ADDENDUM NO. 2

TO: PLANS AND SPECIFICATIONS FOR THE STATE OF MISSOURI

HVAC Improvements
Fulton Reception and Diagnostic Center
Fulton, Missouri
Project No.: C2406-01

M102.L

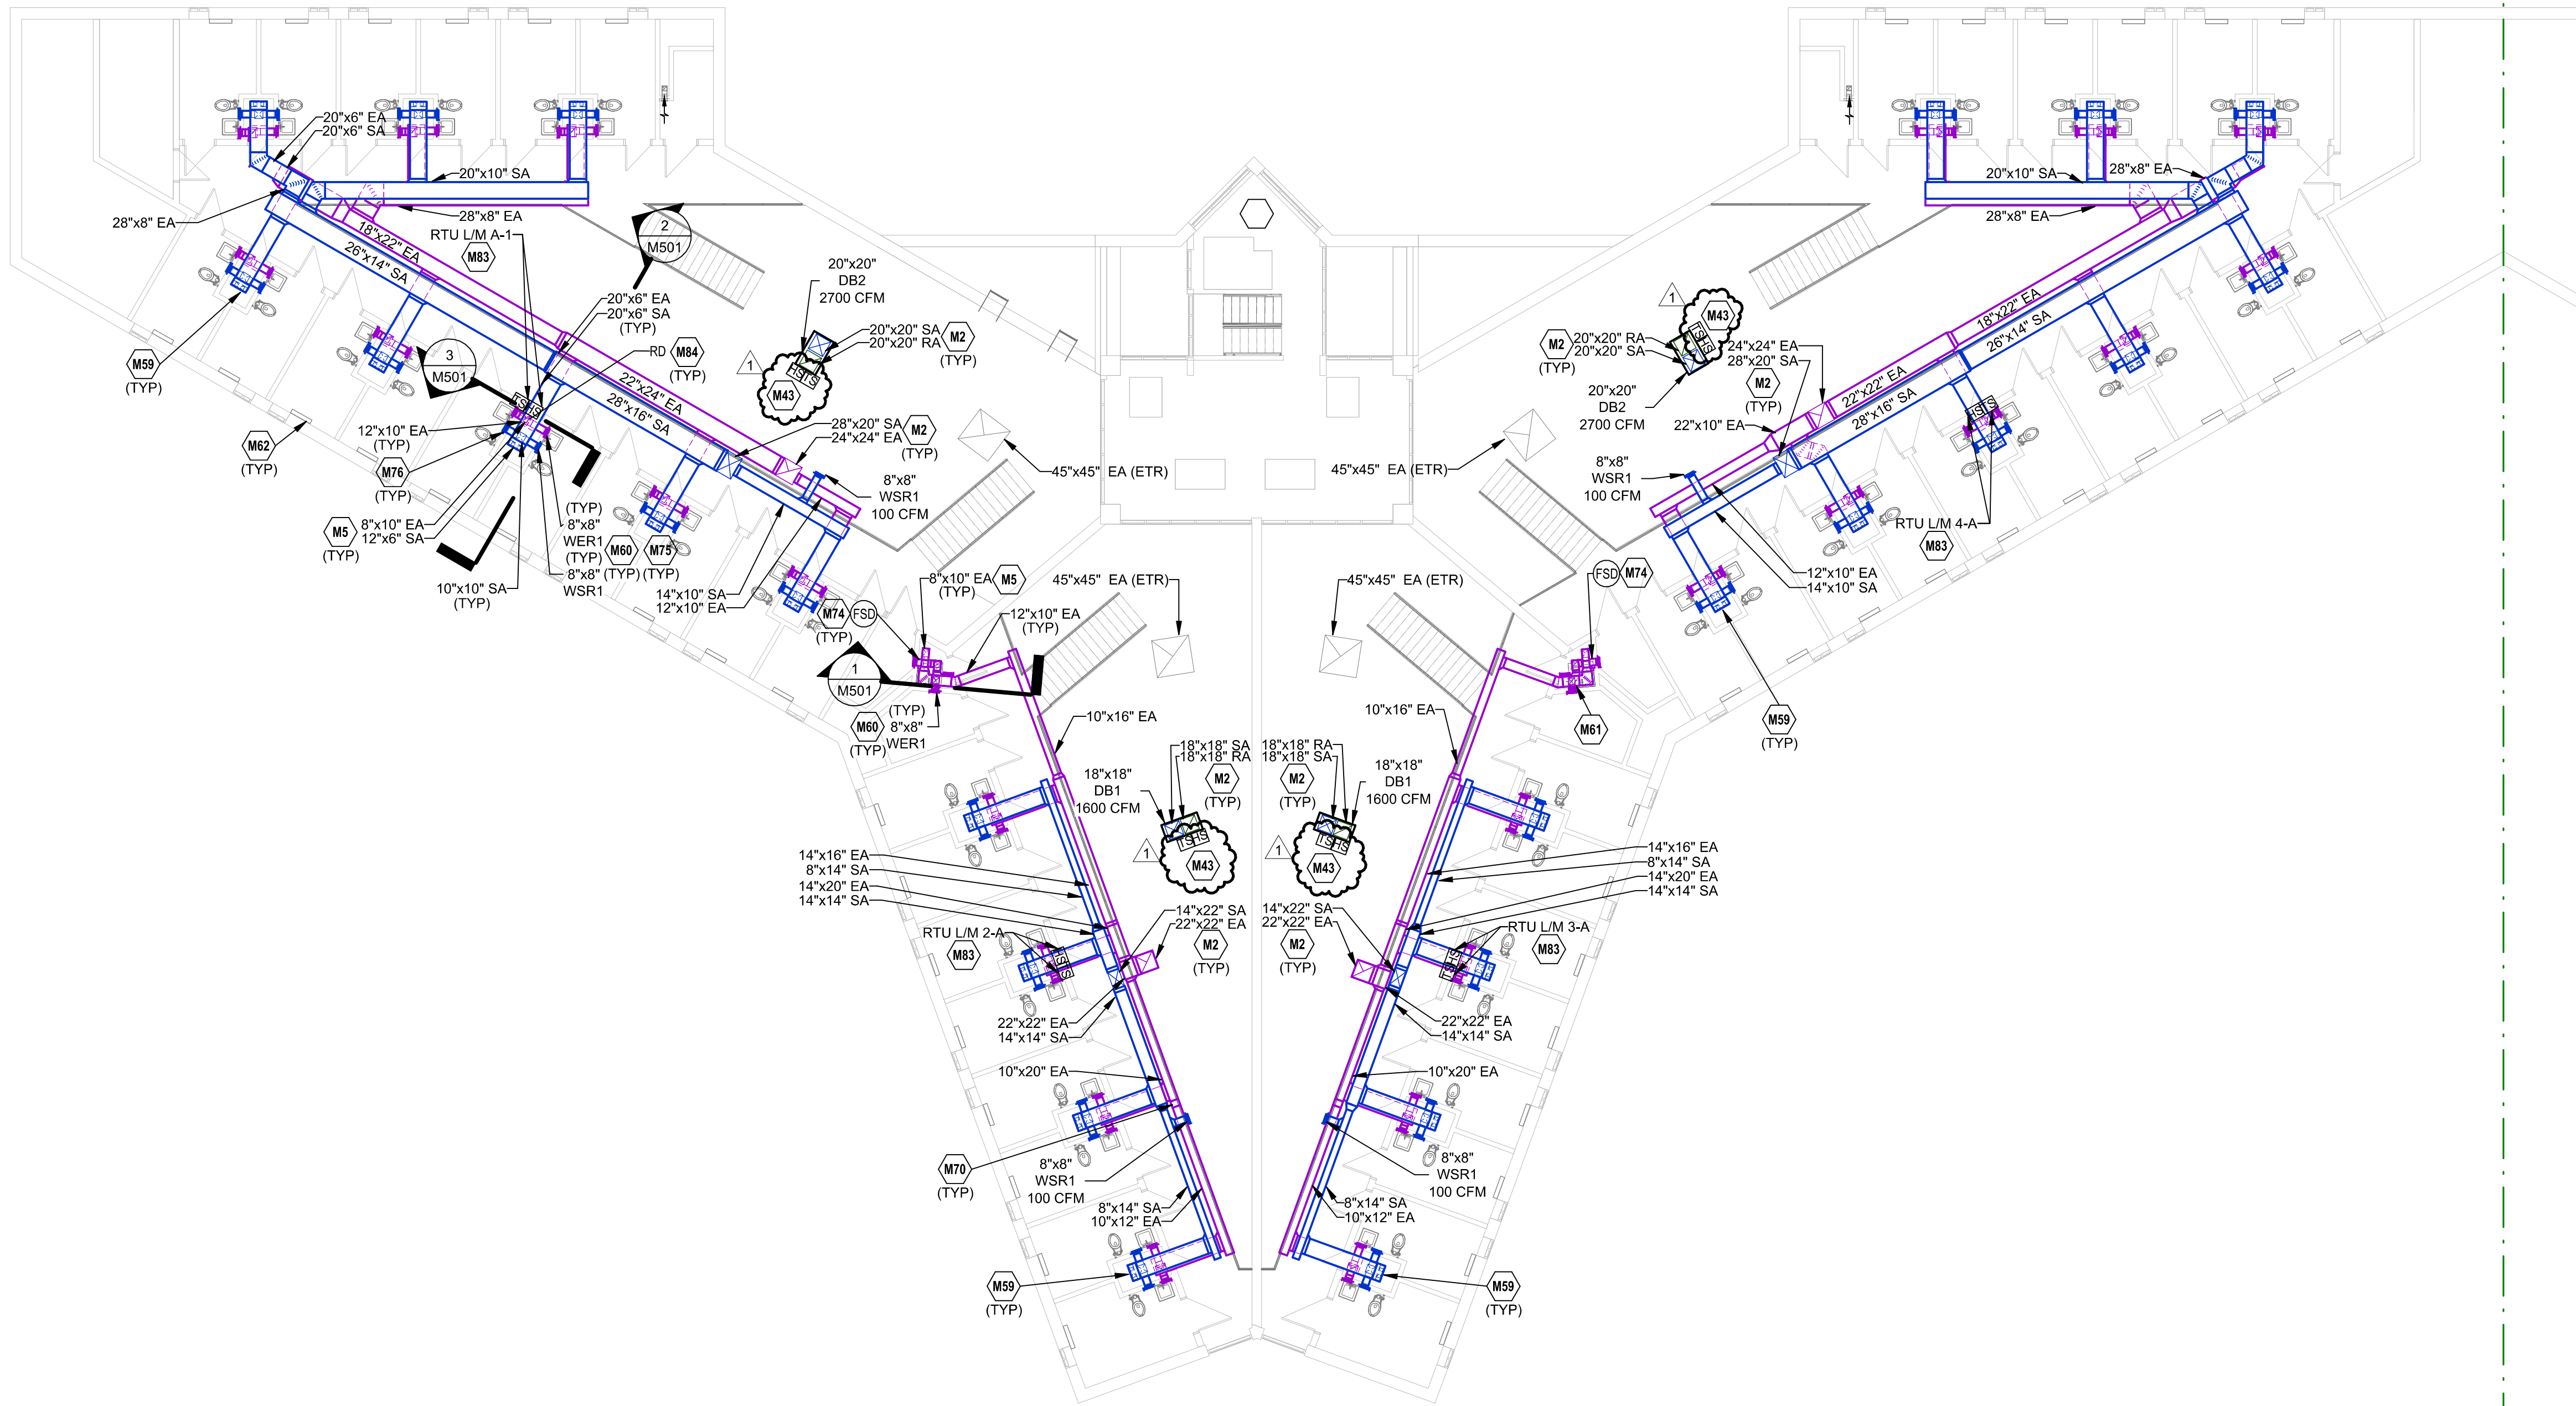
- 1) Add temperature sensor and humidity sensor to return duct at each dayroom RTU.
- 2) Add keynote 43.

SHEET NUMBER:
M103.L

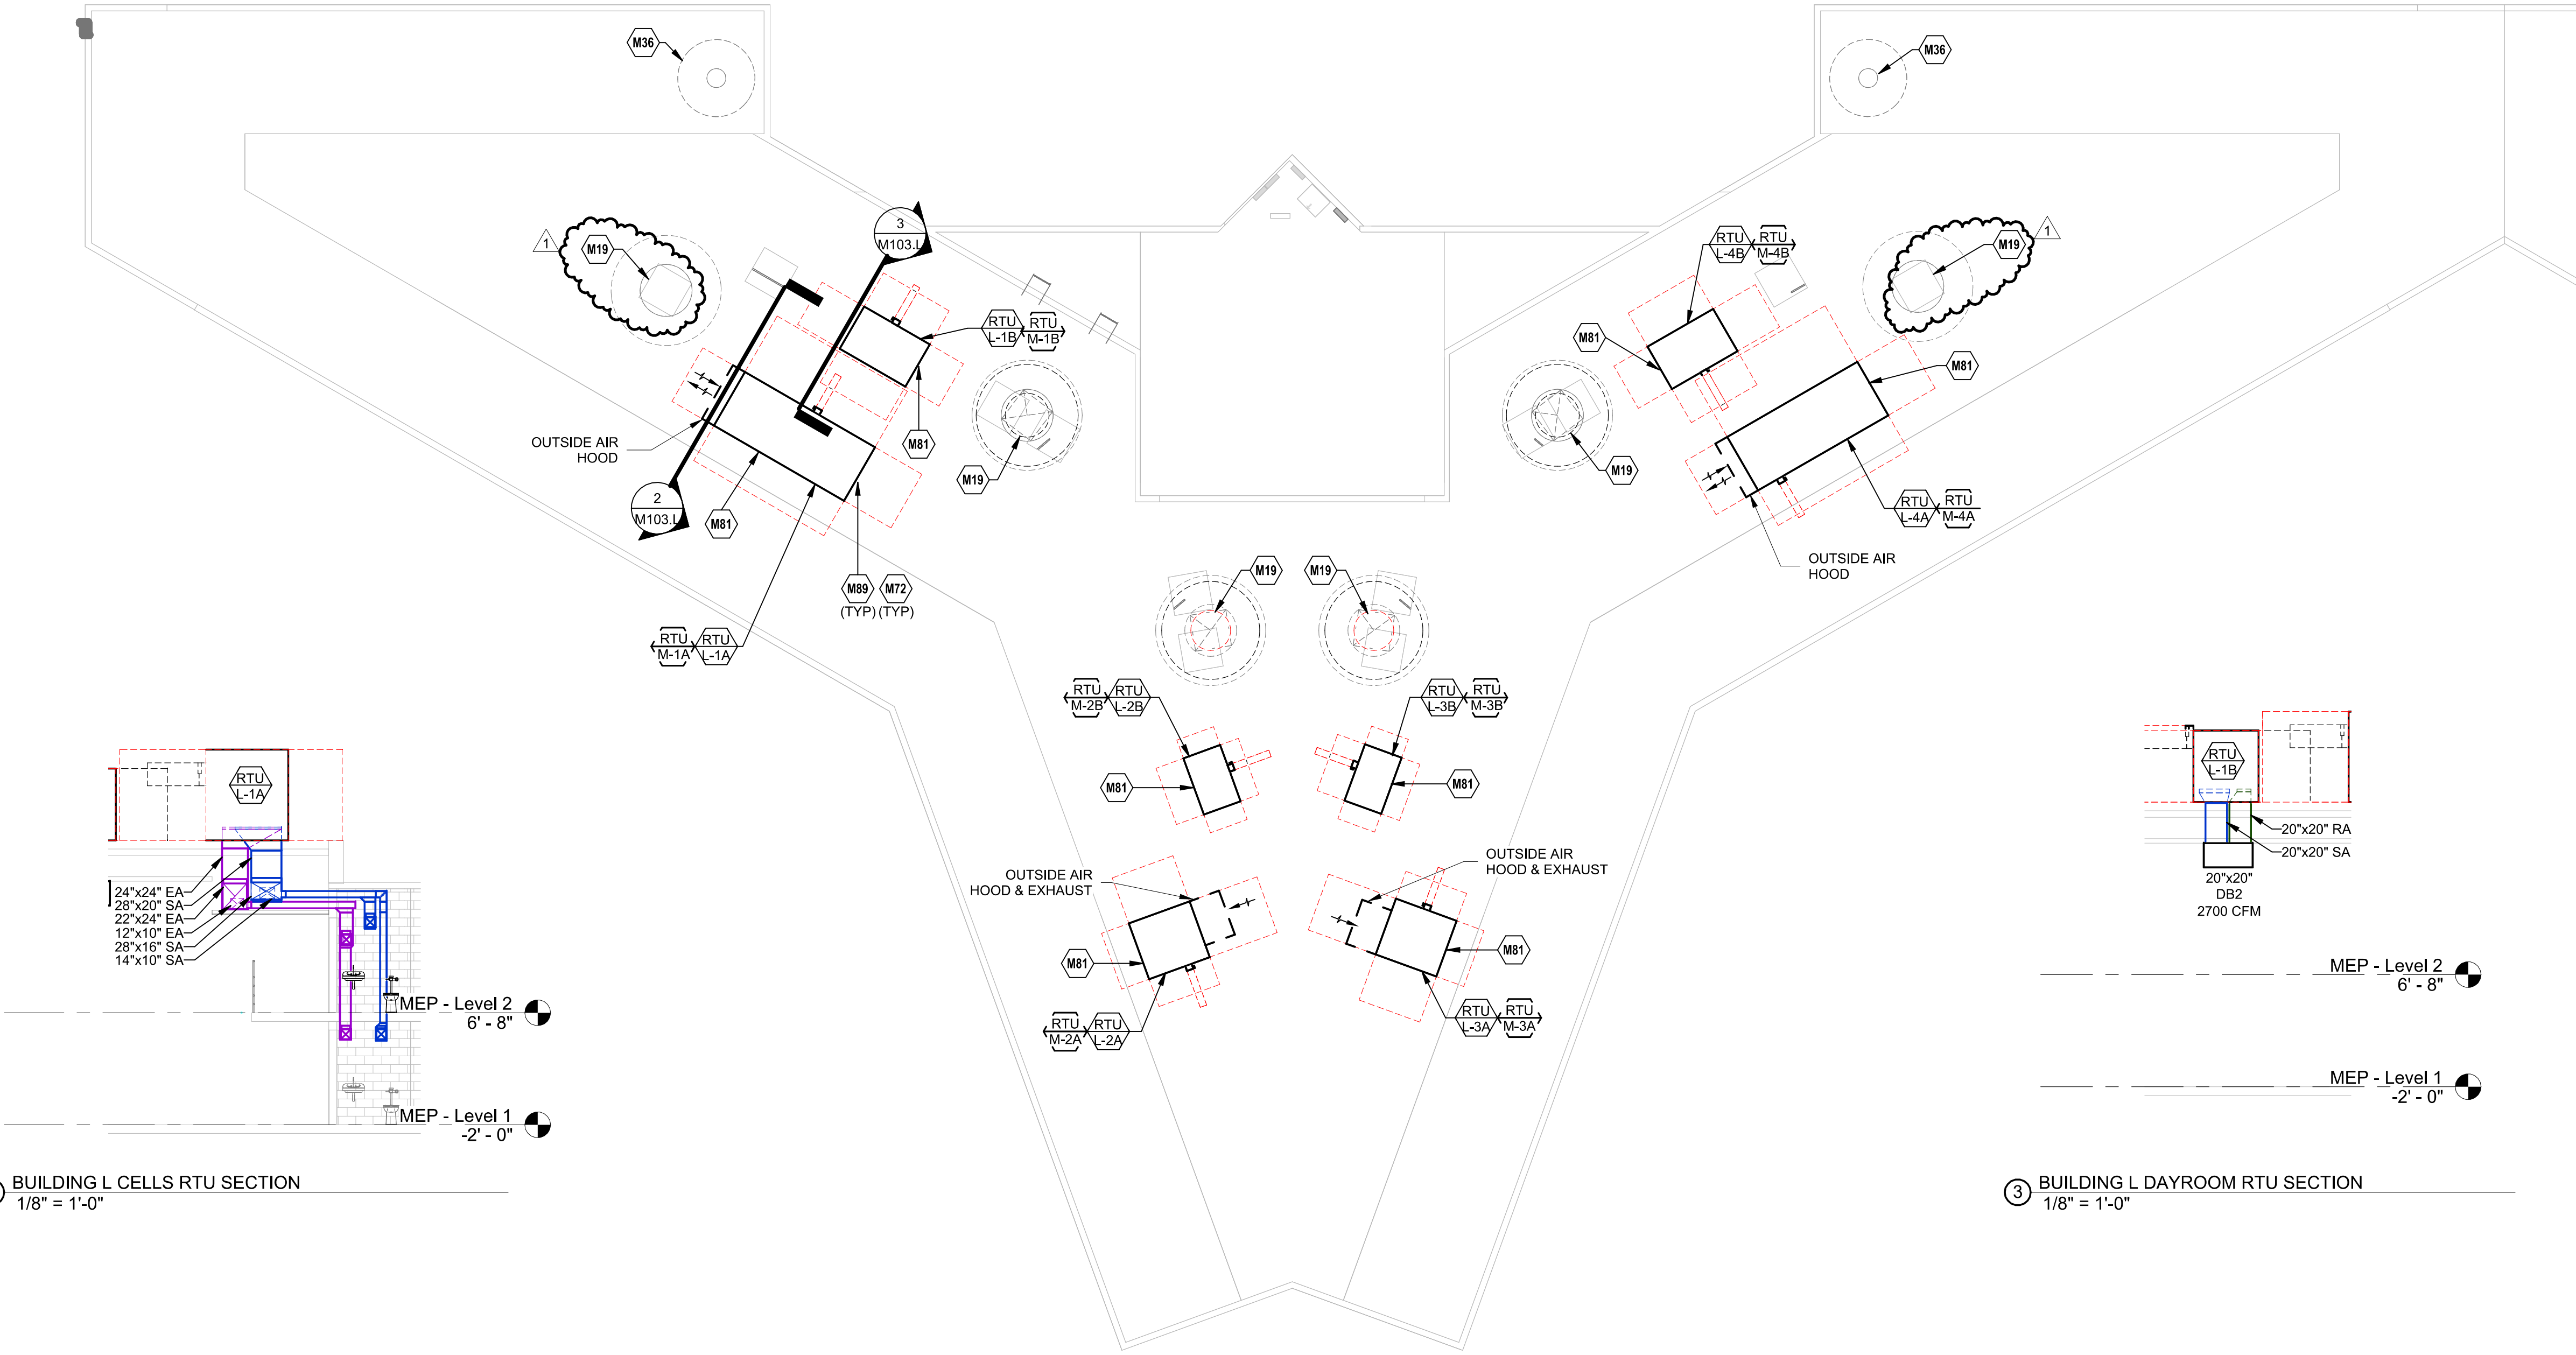
- 1) Revise dayroom ventilation fan keynote 30 to keynote 19 to indicate exhaust fan is to remain and not demolished. Delete keynote 30.

- MECHANICAL PLAN NOTES:**
- M19 EXISTING VENTILATION FAN TO BE ABANDONED IN PLACE AND LOCKED OUT OF SERVICE ALONG WITH ASSOCIATED MOTORIZED DAMPERS AT THE FAN AND INTAKE LOUVER(S). DAMPERS SHALL BE LOCKED OUT IN THE CLOSED POSITION.

1 GLOBAL POINTS MONITORING
NTS

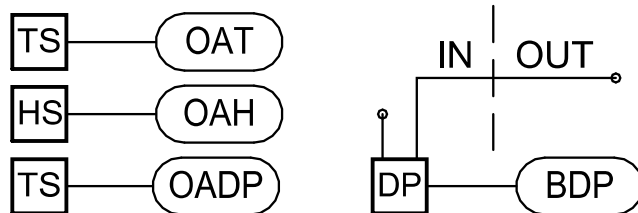
- 1) Revise RTU control matrices to reflect control panels and sensors by RTU manufacturer.
- 2) Add electricity metering to Global Building Monitoring.

6. Modify Note B (Division 23 contractor shall provide device) on M600 to read (Equipment Manufacturer shall provide device).

7. Modify Rooftop Unit Control Matrix on M600 to read Equipment manufacturer shall provide control panel(s), wiring, thermostat(s), temperature sensor(s), humidistat(s), and/or CO2 Sensor(s).

Response: Drawing has been updated as noted. Refer to attached revised drawing.

Response: Drawing has been updated as noted. Refer to attached revised drawing.

EQUIPMENT MANUFACTURER SHALL PROVIDE CONTROL PANEL(S), INTERNAL WIRING, TEMPERATURE SENSOR(S), HUMIDITY SENSOR(S), AND/OR CO2 SENSOR(S) WHERE SHOWN ON THE DRAWINGS AND AS REQUIRED TO FACILITATE THE SCHEDULED CONTROL MODULES AND SEQUENCES OF OPERATION. EACH UNIT SHALL CONTROL BASED ON ITS OWN INTERNAL SAFETIES, TIME DELAYS, AND SEQUENCES UNLESS NOTED OTHERWISE. COORDINATE WITH OWNER FINAL BUILDING AND EQUIPMENT SCHEDULES DURING STARTUP. REFERENCE DIVISION SPECIFICATIONS FOR INDIVIDUAL DEVICE REQUIREMENTS. ALL EXTERNAL CONTROL WIRING SHALL BE BY DIVISION 23 CONTRACTOR.

B. EQUIPMENT MANUFACTURER SHALL PROVIDE DEVICE.
C. EQUIPMENT MANUFACTURER SHALL PROVIDE DEVICE.
D. EQUIPMENT MANUFACTURER SHALL PROVIDE DEVICE.
E. EQUIPMENT MANUFACTURER SHALL PROVIDE DEVICE.
